SI B11 06 18
Engine

TURBO BOOST ACTUATOR ROD LOOSE (DIESEL)

With the N47T or N57T Diesel Engines

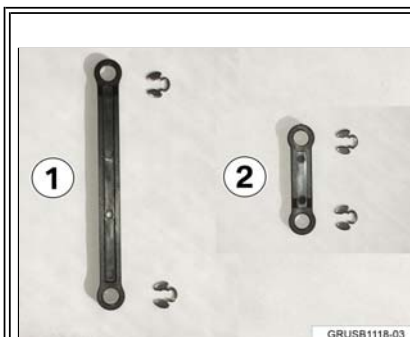
The clips that hold the boost actuator rod for the variable nozzle technology (VNT) turbo have come loose (1).

A new repair kit has been introduced that includes improved clips and a new actuator rod for N57T (1) and the N47T (2).

|  | <p>Replace the rod (1) and clips (2) on the VNT actuator/turbo. NOTE: Turbo removed for clarity. The turbo does not need to be removed to complete repairs.</p> |
